February 20, 2025

From: Max Foley
 Medici Architects
 max@mediciarchitects.com

RE: Public Comment Response to email dated 7/2/2024

From: leasing avellinoapartments.com <leasing@avellinoapartments.com>
Sent: Wednesday, June 26, 2024 3:59 PM
To: Ryan Harriman
Subject: RE: 2900 78th Ave SE File # DSR24-010 & SEP24-009

Figure 2 — Retail Use Required Adjacent To Street Frontages

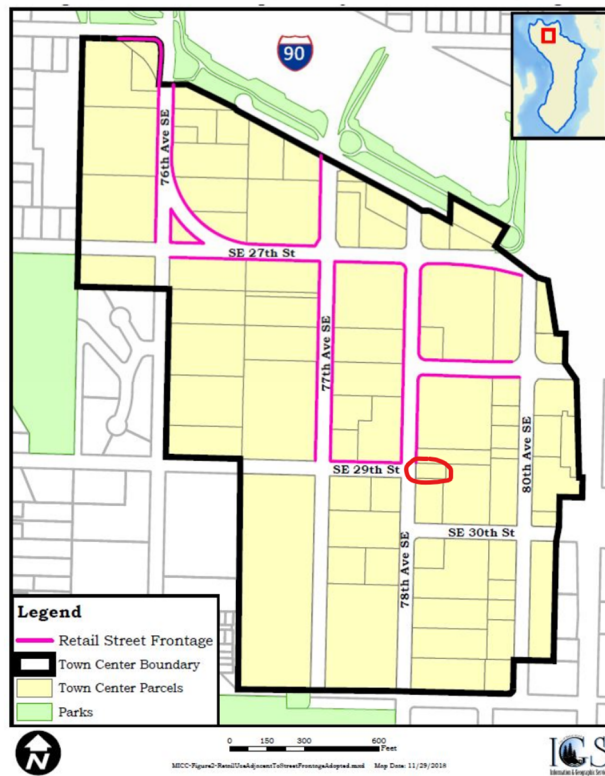
I am responding to the Public Notice of Application. First of all, I am sorry, but this section was never supposed to be residential only, it was supposed to be commercial as it is in the Town Center core, is it not?

I don't think they realize when they state: the proposed development provides stacked **multi-family residences** with primary pedestrian and vehicular access from 78th Ave SE." It is not 'multi-family' And it has where **RETAIL IS REQUIRED**, but the proposed building is not offering any retail. See map below:

- Per MICC 19.11.020 Land Uses, residential uses are permitted in the TC-4 zone. At the time this project was vested under the MICC, retail frontage was not required for any parcels south of the Avellino Apartments (2836 78th Ave SE). Please refer which reflects the applicable MICC regulations at the time of vesting. The Baskin-Robbins site is circled in red, illustrating that this site along with all other sites south along 78th Ave SE was not subject to retail frontage requirements.

- Per MICC 19.11.020 Land Uses, residential uses are permitted in the TC-4 zone. At the time this project was vested under the MICC, retail frontage was not required for any parcels south of the Avellino Apartments. Please refer to Figure 2 when this project was vested under the applicable MICC version. The Baskin Robbins site is circled in red and as you can see, this site and all sites south along 78th Ave SE did not require any retail frontage.

Landscaping

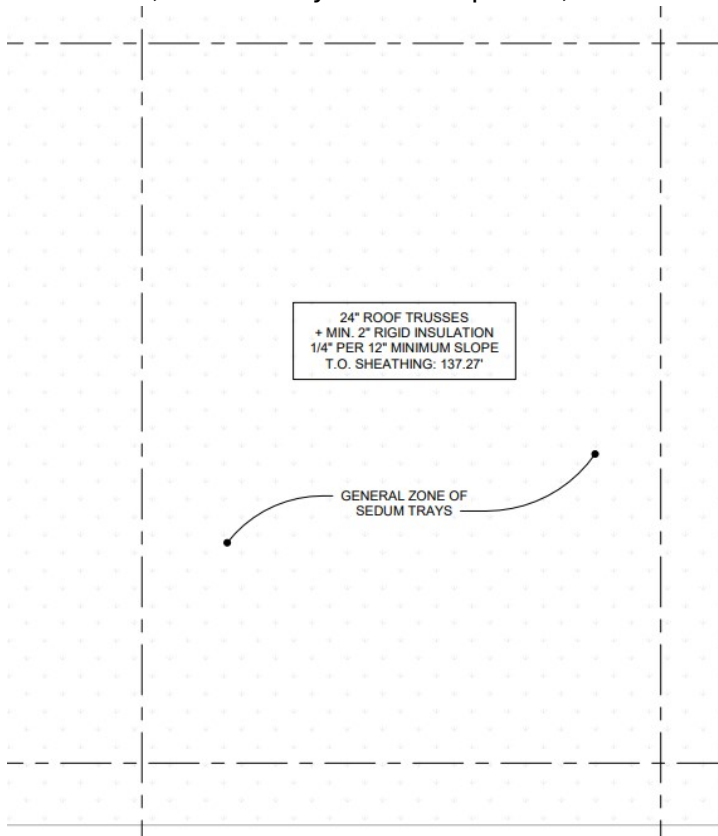
It says that 3,250 sf of sedum trays on the roof, but if you look at the plans on page 7, it does not show 3,250 sf of sedum trays, it shows a portion. And are you trying to say, that they can go across the road, buy a few trays of sedum and put them on the roof, and that is sufficient?

As I am a layman and don't know how to read plans, how much exactly is it showing? I

- Green Roof – This will be largest portion of landscaping on site. There will be approximately 3,250 SF of sedum trays on the roof, which 1,625 SF will count towards the requirement.

- a) And what happens if the greenery dies?
- b) That would mean that they are below their landscaping requirement, what happens if they fall below the required landscaping requirement?
- b) Is someone going to be watering the sedum?

If you look at the plans, it has a section of the roof as for the sedum trays on a portion and not even on the whole roof, I doubt very much it equals 3,250 sf of roof space?

Is the roof going to be sloped or flat? It is hard to tell.
